Mold Road, Gwersyllt, Wrexham - Proposed Residential Development S278

Stage 2 Road Safety Audit

Report Title:	Mold Road, Gwersyllt, Wrexham - Proposed Residential Development S278
Report Produced for:	Wrexham County Borough Council
Report Dated:	17 August 2026
Document Reference & Revision:	MAL/MRGW278RSA2 Rev0
Report Produced by:	Meraki Alliance, Watkin Avenue, Old Colwyn, Conwy LL29 9NN Jonathan Birkett 07966296302
On behalf of:	SCP

Problem Location Plan

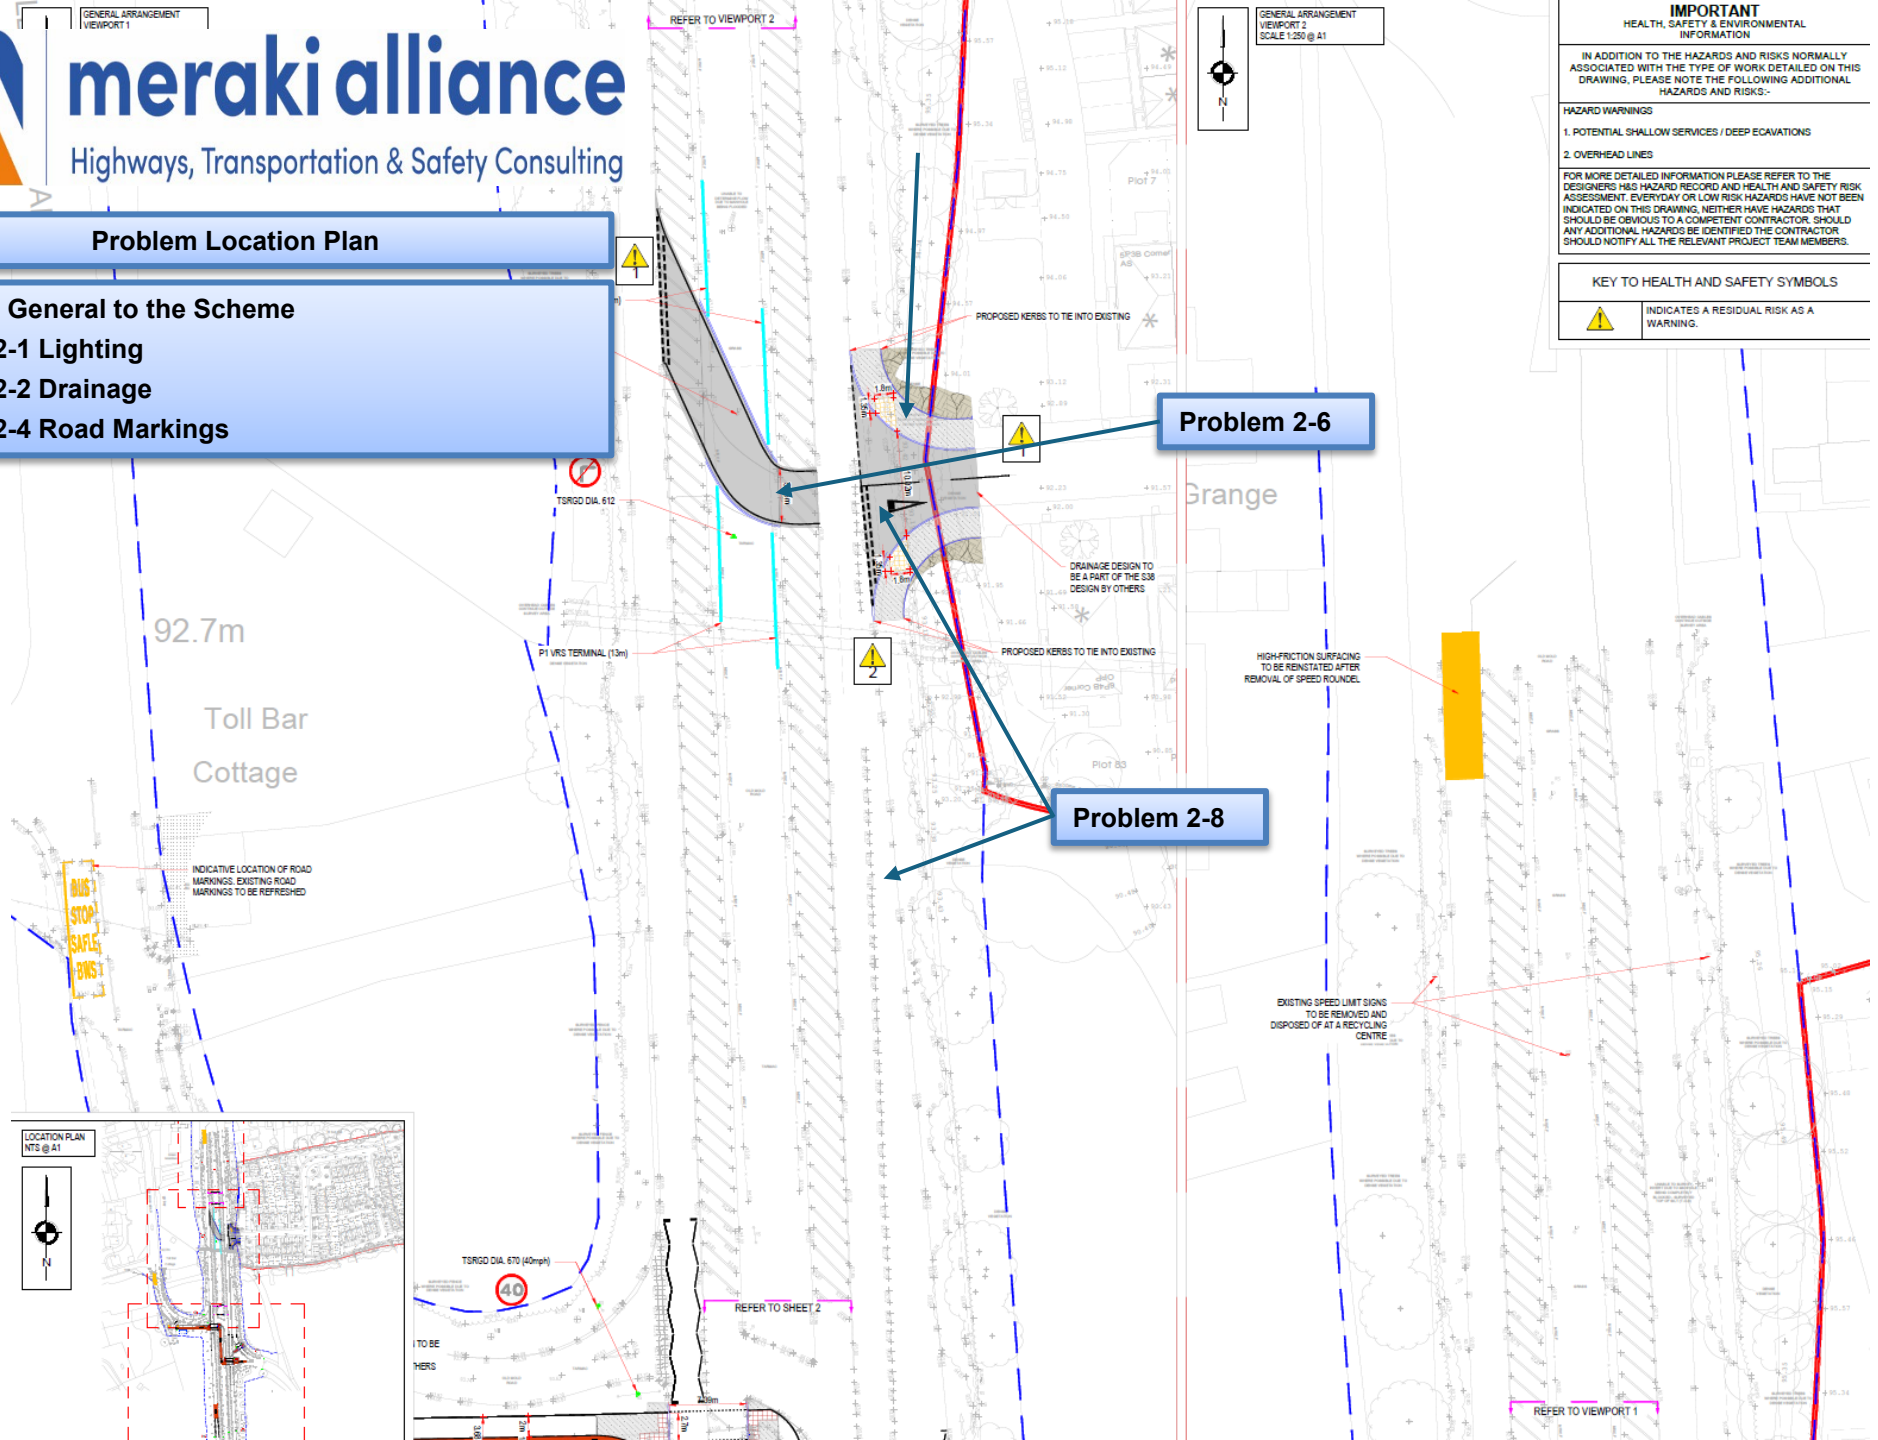
Problem 2-1 Lighting

Problem 2-2 Drainage

Problem 2-4 Road Markings

Problem 2-6

Problem 2-8
